ALCW2015 Accelerator Report

K. Yokoya
2015.5.15 LC推進委

Issues

CR2: Common L^*

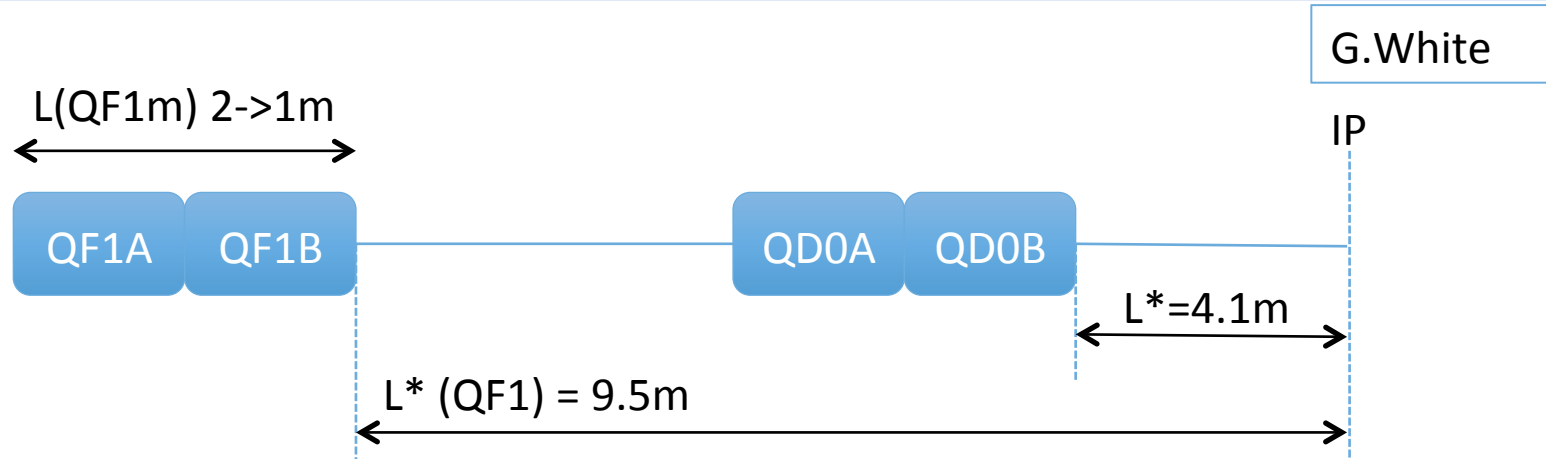
- Change request from accelerator side to make L^* common to SiD and ILD for easier commissioning and tuning
- SiD designed with $L^*=3.5$ m can relatively easily accept L^* between 2.6 and 4.5 meters.
- ILD designed with $L^*=4.5$ m can accept the minimum L^* of 4.1 m by removing the ion pump in front of QD0.
 - Increased pressure seems to be acceptable
 - Backup solution using a distributed NEG system is under consideration. Seems ok.
 - Further modification (e.g., redesign FCAL) needed if $L^*<4.1$ m is required
- The difference between $L^*=4.0$ and 4.1m is negligible from the optics and tuning standpoint.
- Once L^* decided, there is still a choice for QF1 L^* (9.5m in TDR)
 - Shorter QF1 L^* leads redesign of QF1 support structure and Packman both on SiD and ILD.
 - But 9.5m and 9.1m do not cause significant difference in optics

- Common L* of 4.1 m
- Taking all currently available information, the CRP recommends that CR-002 being accepted as baseline, with an agreed-upon common L* of 4.1 m.
- As a further corollary to this study, the CRP also recommends that QF1 L* be left at the TDR value of 9.5 m.
- With QD0 L* set at 4.1m, the BDS performance was evaluated for a range of QF1 L* values. A weak dependence is observed when lowering the QF1 L* from 9.5 m, whereas the collimation depth calculations show a preference for an L* of around the TDR design value of 9.5 m.
- Shorter QF1 L* leads redesign of QF1 support structure and Packman both on SiD and ILD.

ILC-CR-0003

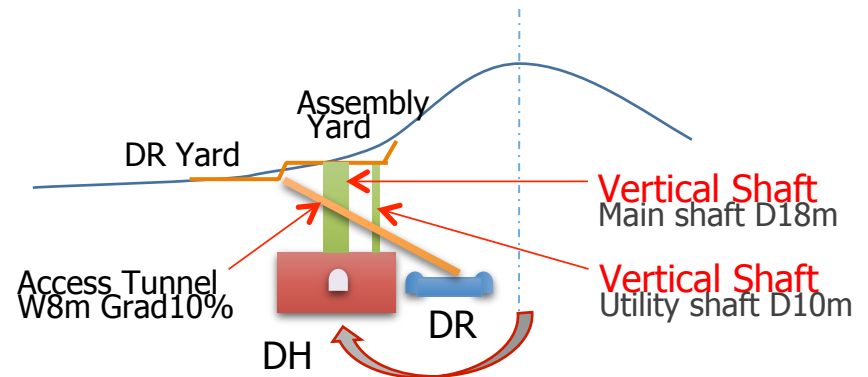
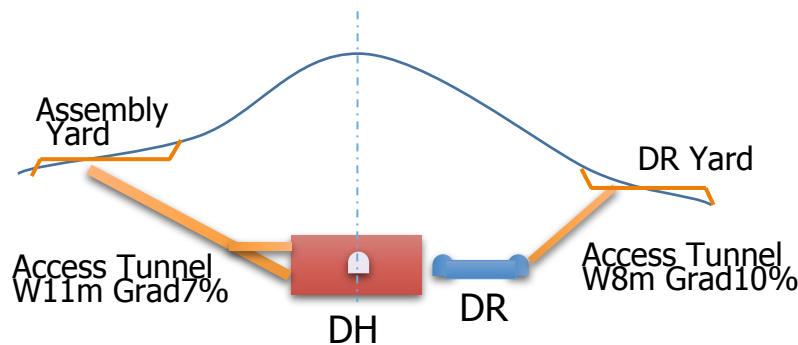
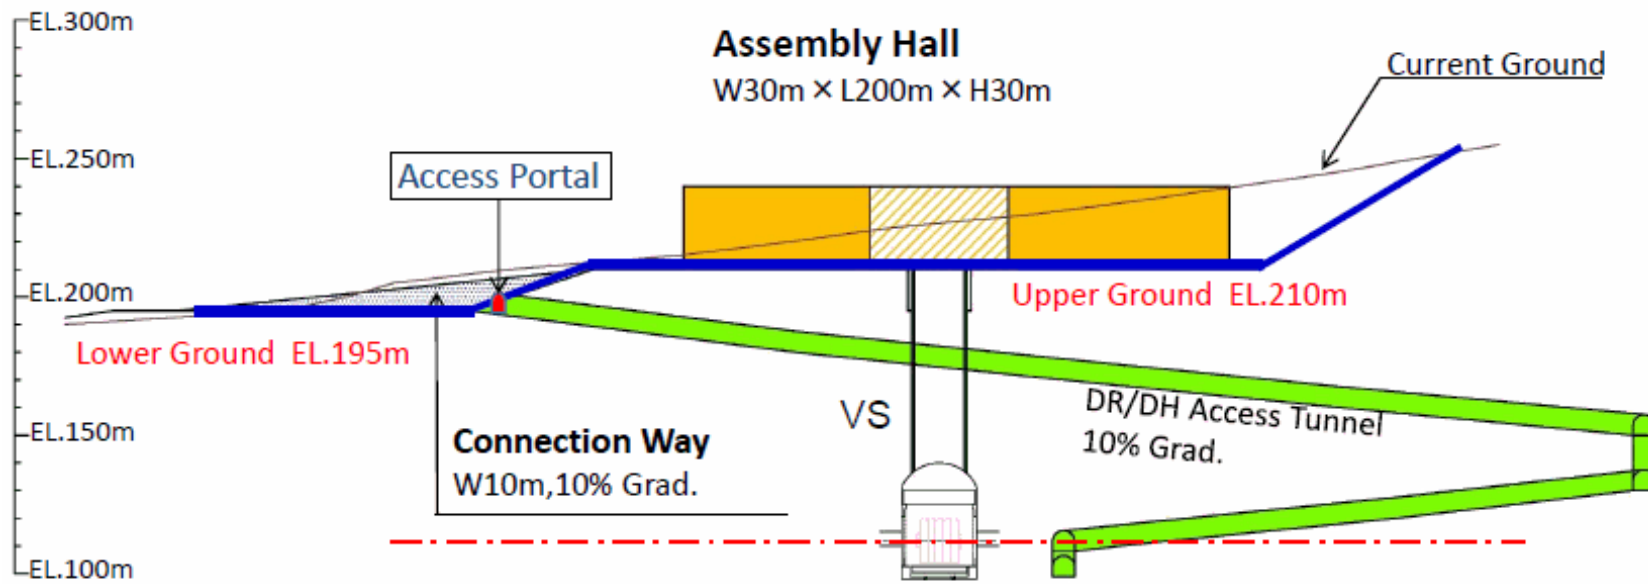
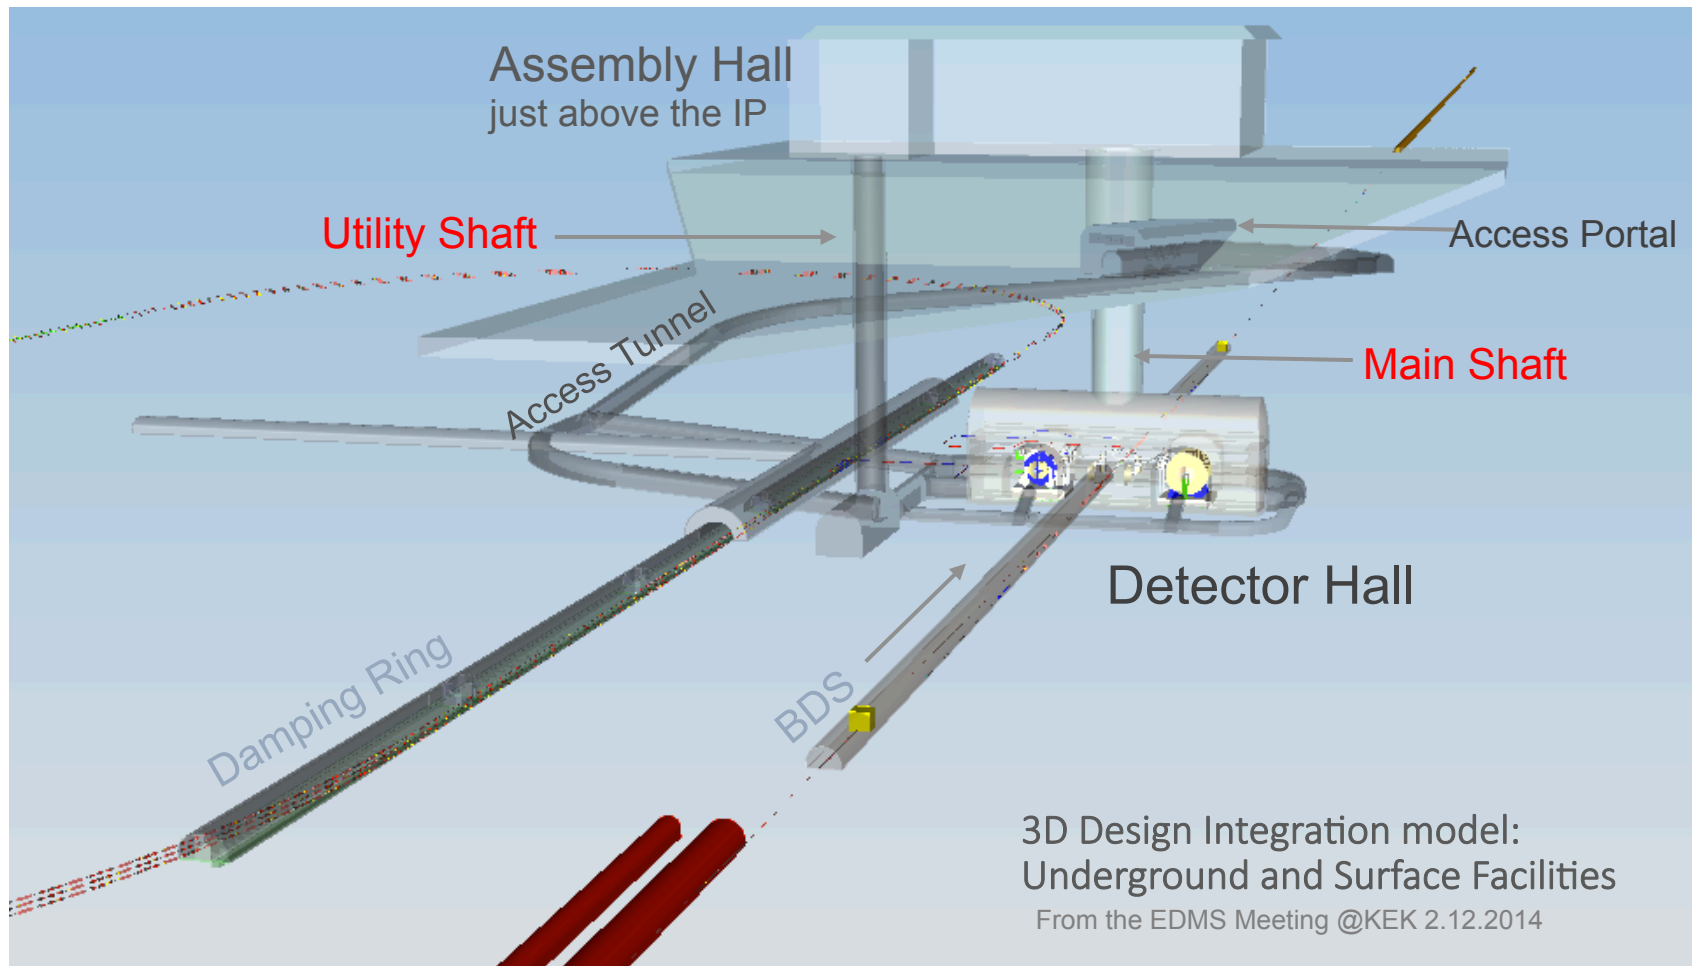
- Horizontal access → mainly vertical shaft around IP
- Implementation team named
 - V Kuchler, K Buesser, T Markewicz, M Miyahara, J List, B List, (T Sanuki, Support)
- Discuss about
 - ✓ Location of the Overall ILC Alignment to Optimize the Preferred Site Conditions
 - ✓ Path and Configuration of the Horizontal Tunnel Access to the Detector Hall and Damping Ring
 - ✓ Vertical Shafts (2) for Access to the Detector Hall
 - ✓ Footprint and Configuration of the Detector Hall
 - ✓ Crane Requirements for the Detector Hall
 - ✓ Overall Construction and Detector Assembly Schedules
 - ✓ Cost Implications for the Required Changes (~ -5%)

- Assembly Place: underground/DH
- Access way to DH underground
 - only horizontal **Access Tunnel (AT)**
 - Transport. by special long trailer

- Assembly Place: Surface building/AH
- Access way to DH underground
 - mainly **Vertical Shaft (VS)**
 - Transport. by Gantry Crane

- Change Review Panel Members: K. Yamamoto, V. Kuchler
- Current Status: Accepted by CMB

CR-004

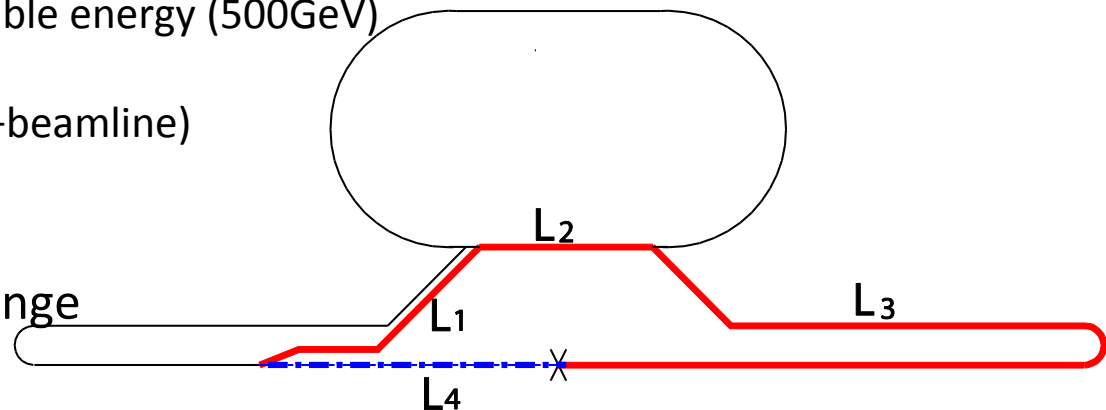
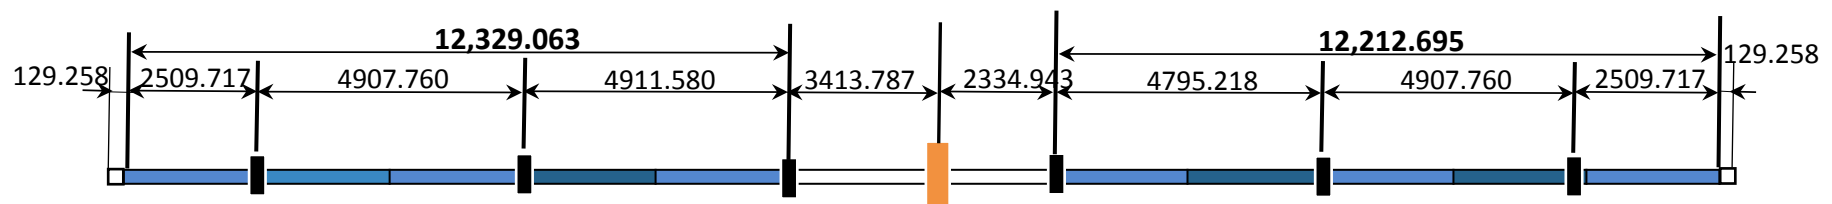
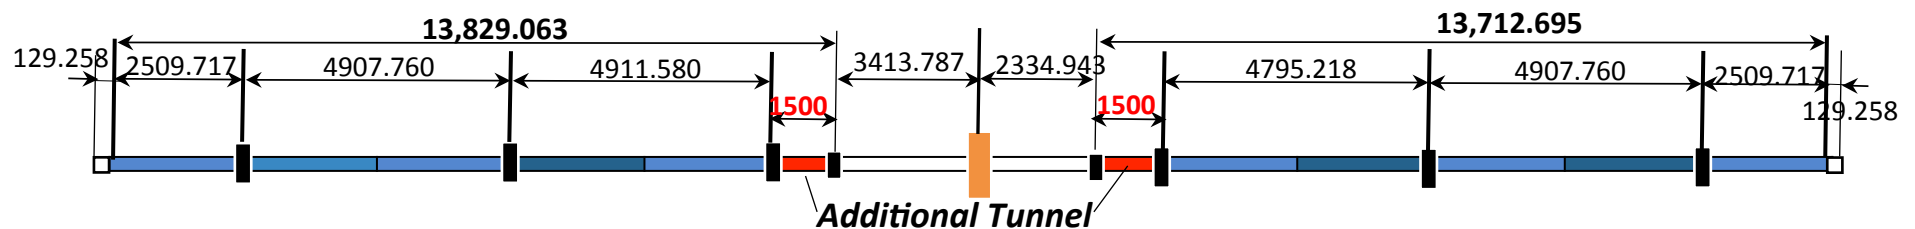
- Global timing issue
 - $(L_1 + L_2 + L_3) - L_4 = n \times C_{DR}$
 - Linac (positron) tunnel length discrete by $C_{DR}/2$
 - TDR values $(L_1 + L_2 + L_3) - L_4 = 9 \times C_{DR} + 294\text{m}$
 - Near-TDR solution
 - Decrease BDS by $294\text{m}/2$
 - Or, increase C_{DR} by $\sim 40\text{m}$ (and increase BDS slightly)
- Perhaps more reasonable solution is to increase the linac tunnel length by $2 \times 1.5\text{km}$
 - Empty tunnel (with beamline) in the first construction
 - Future margin $\sim 14\%$ for
 - Acceleration gradient ($31.5\text{MV}/\text{m}$)
 - Or, maximum reachable energy (500GeV)
 - Cost impact
 - ~ 100 MILCU (tunnel+beamline)
- Additional equipment
 - Positron chicane in L1 to adjust 10's of cm range

ML Shield wall thickness impact

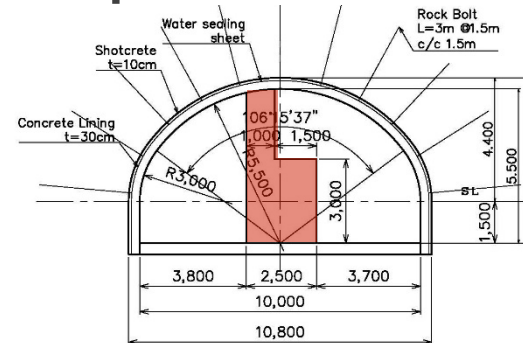
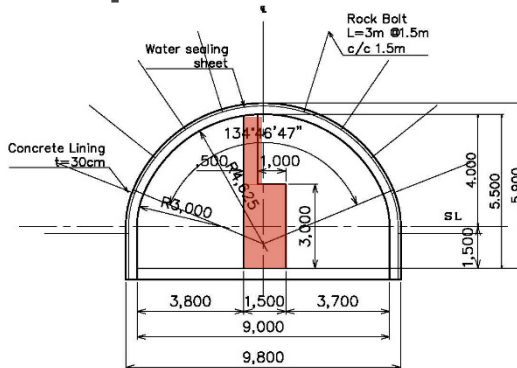
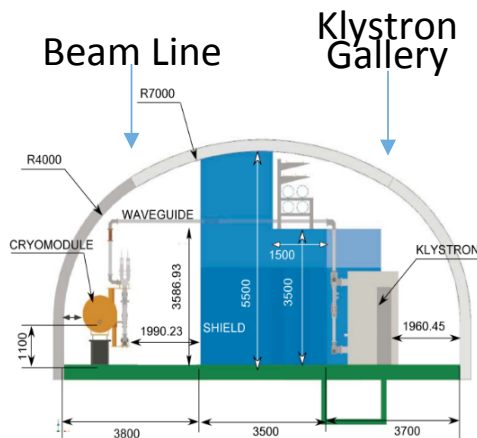
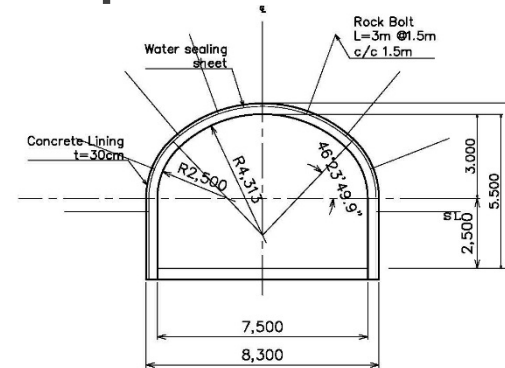
- Radiation shield issue will be decided by necessity of person's access
- **Scheme change depends on the management scenario of beam operation.**

Several studies presented in this workshop
Failure modes, dark current
For the wall thickness, the main issue is the
policy

Scheme change – BDS Configuration

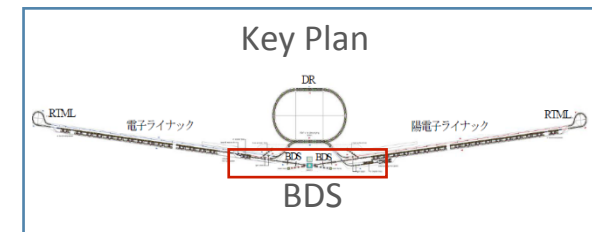
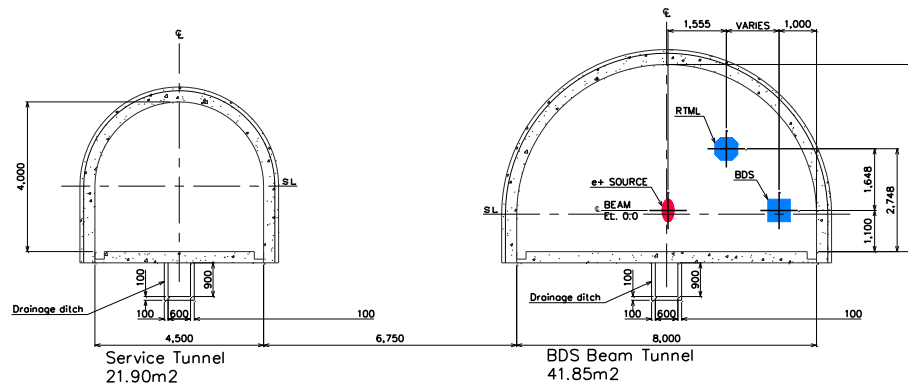
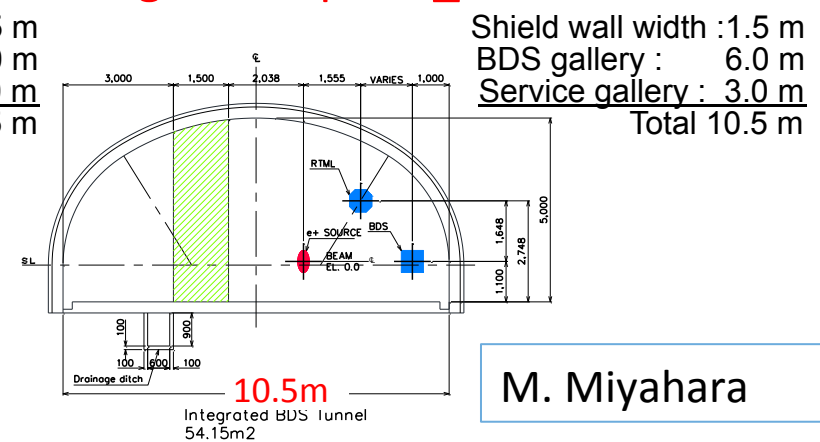
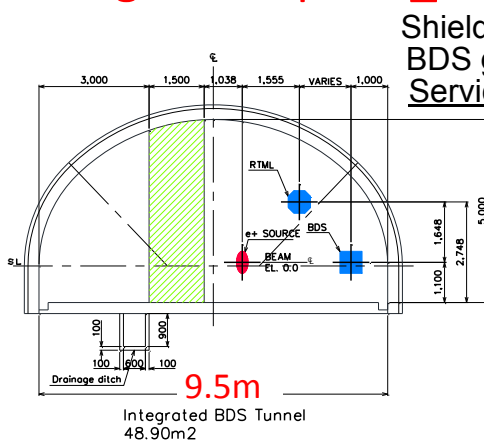
- Change to the **single tunnel** from the twin tunnel in TDR
- BDS group is currently discussing the various layout options
